Noise Symptom - Creaking Noise from Body Front Area of the Vehicle: Replacing Upper Trailing Arm (SY 265/22)

Model Line: **Taycan (Y1A/Y1B/Y1C)**

Model Year: **As of 2020 up to 2023**

Installation position of upper trailing arm

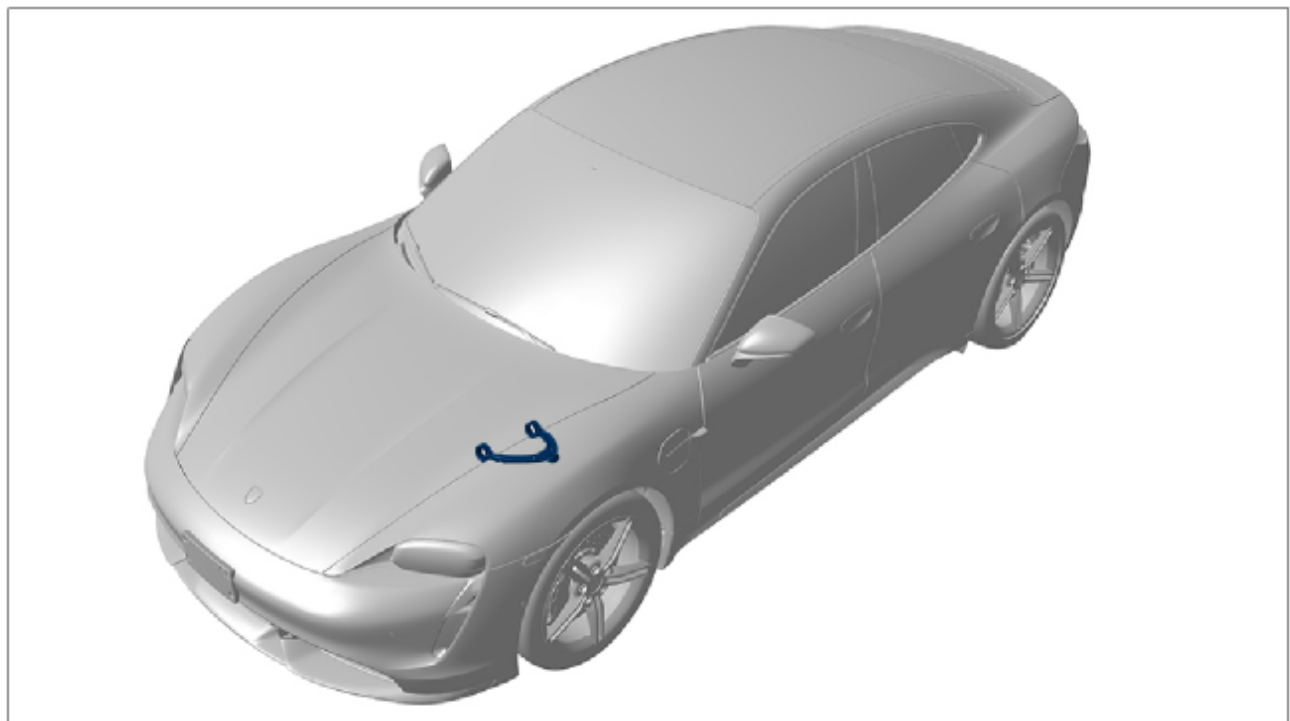
Symptom: **Creaking noise from body front section area at temperatures below -5 °C (23 °F).**

Cause: Under certain conditions, the arrangement of the upper trailing arm rubber bearings with respect to the body side can cause creaking noises.
Temperatures below -5 °C can increase these noises.

Remedial Action: A new component status is available for the upper left and right trailing arms on the front axle.
In the event of a comprehensible customer complaint, replace the upper left and right trailing arms on the front axle.
